Gachsaran Polymer Industries Company	Gachsaran Polymer Industries Company HDPE Plant		
	General Arrangement Drawing (2D) (*Tie-In Points , Skid Dimensions & Orientation, Including Instrument, Junction Box and Local Panel Location Layout & Instrument Cable routing.) for Refrigerator Package	 	
PO No.: GPIC-PT-MA-PO-000-3029	Document Number: VD-GPIC-MA-3029-3029-0062	Rev. 03	Page 1 of 11

General Arrangement Drawing (2D) (*Tie-In Points , Skid Dimensions & Orientation, Including Instrument, Junction Box and Local Panel Location Layout & Instrument Cable routing.) for Refrigerator Package

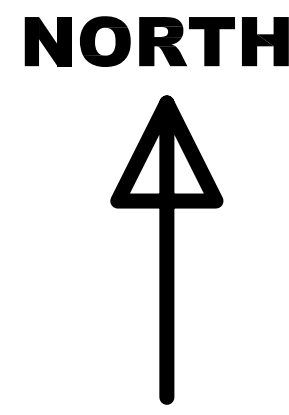
- 1- repeated comment: Vendor shall specify the "Allowable nozzle loads" table for tie-in points at this document.
- 2- repeated comment: Fixed(semi-anchor) **pipe supports** shall be considered close to the tie-in connections with EIED.
- 3- repeated comment: Stress Analysis Report including Caesar II native files for critical pipes inside package shall be provided by vendor.

PI COMMENT:
 -The customer (EIED) shall provide with the STP and navies file of model.
 -Since EIED has TI in/out with vendor in this points (S-42,43,44,T-4A) so their locations and distances from reference point shall be specified in views.
 -Since the direct connection of some lines (Except T-51,T-52,T-4CWS,T-4CWS,T-1A,T-2AI that are in boundary skids) may cause clashes with the lines inside the package, the TI in/out shall be specified in boundary skids.

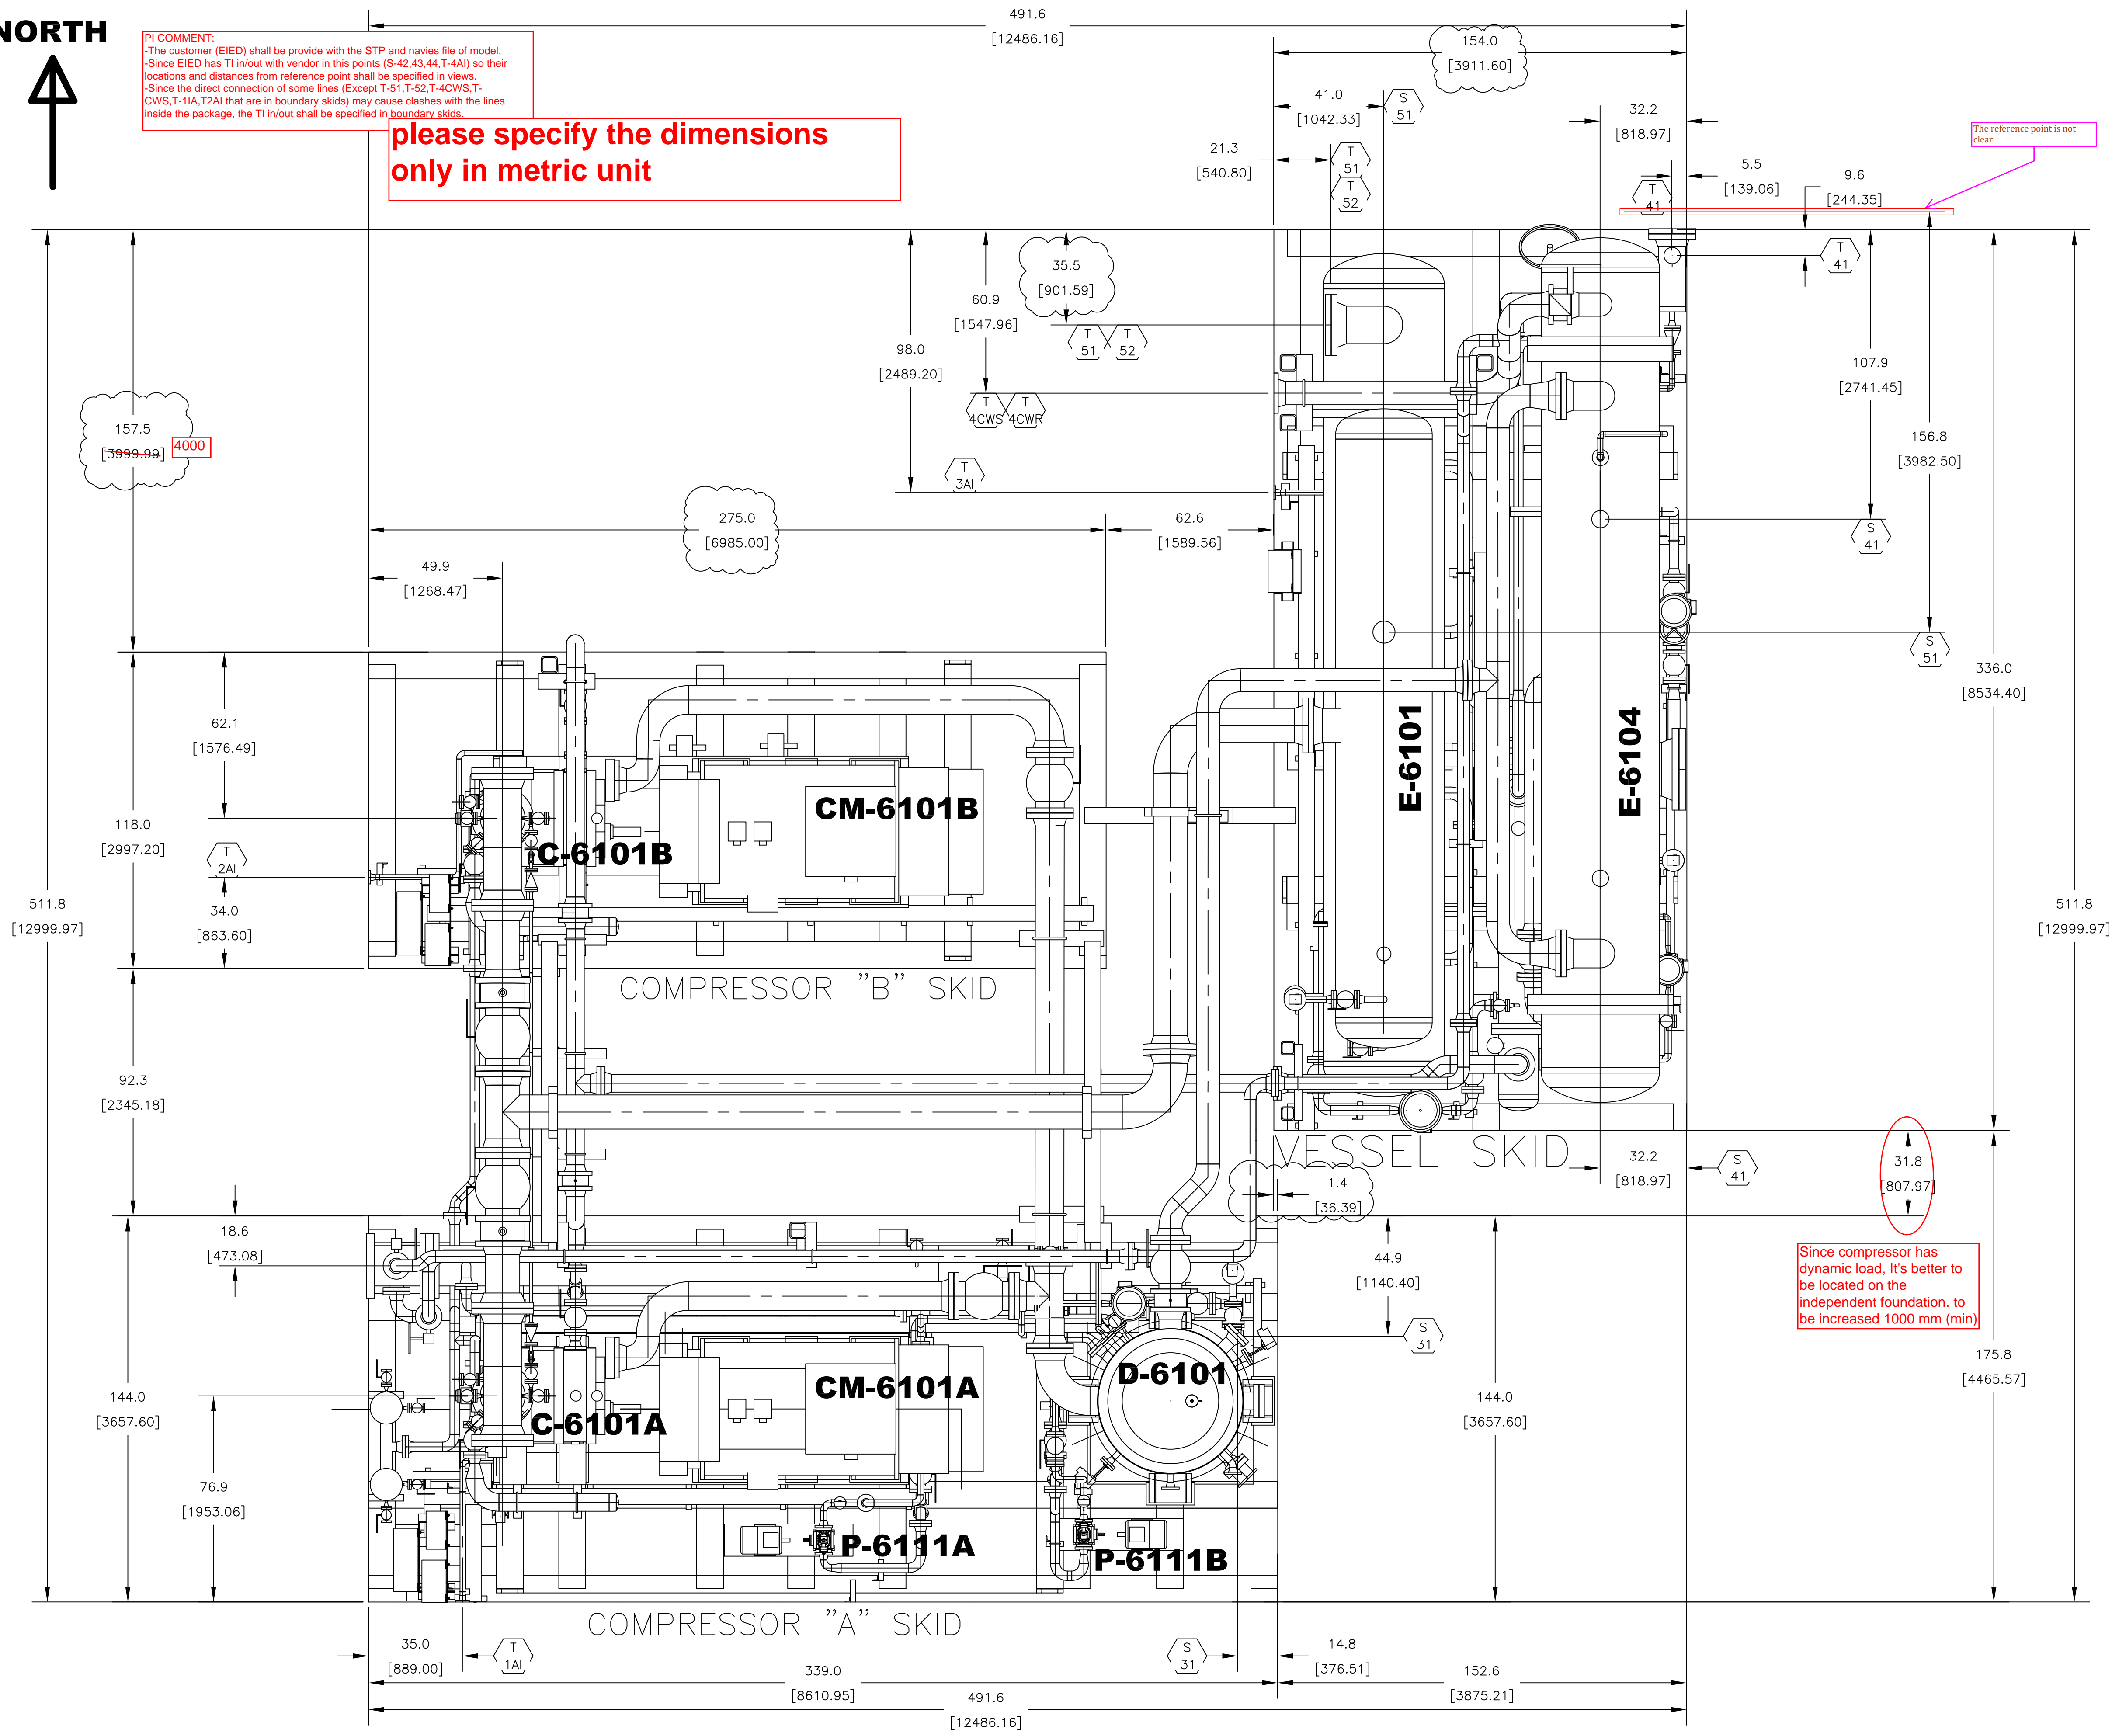
please specify the dimensions only in metric unit

Since compressor has dynamic load, It's better to be located on the independent foundation, to be increased 1000 mm (min)
